CEA: Draft Guidelines for Resource Adequacy Planning Framework for India

CER Opinion

Figure 1: Case demonstration to understand the impact of capacity tie-up

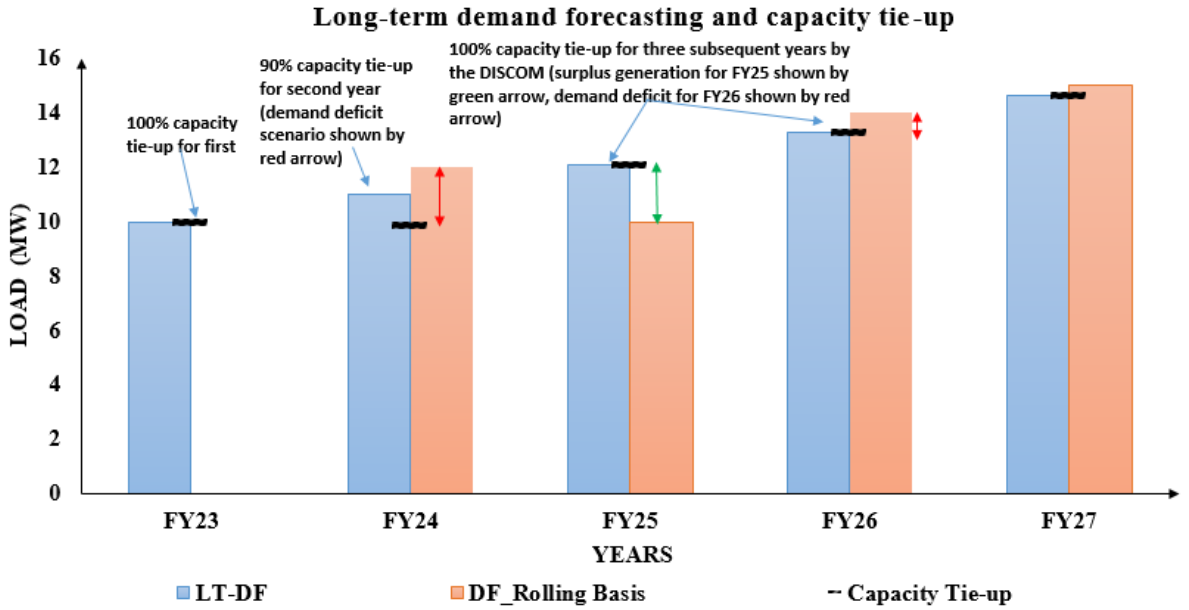
As per the Clause, the capacity tie-up by the DISCOM is indicated in the figure. The figure indicates that there may be a potential occurrence demand deficits during the 2nd year due to low tie-up capacity (90%) as compared to 1st year (100%). A scenario of surplus capacity can also take place in the 3rd year of 100% of capacity tie-up. Thus, the above tie-up process can be implemented in a more effective way.

EAL suggests the following rollout plan for resource adequacy planning:

a. DISCOM shall demonstrate 85-90% tie-up of resources for the 1st year and 2nd year. (immediately after rollout of RA plan)
b. DISCOM shall demonstrate 95% tie-up resources for the 3rd year.
c. DISCOM shall demonstrate 100% tie-up resources for the 4th year onwards.
d. The tie-up resources now can be brought down for the subsequent years.
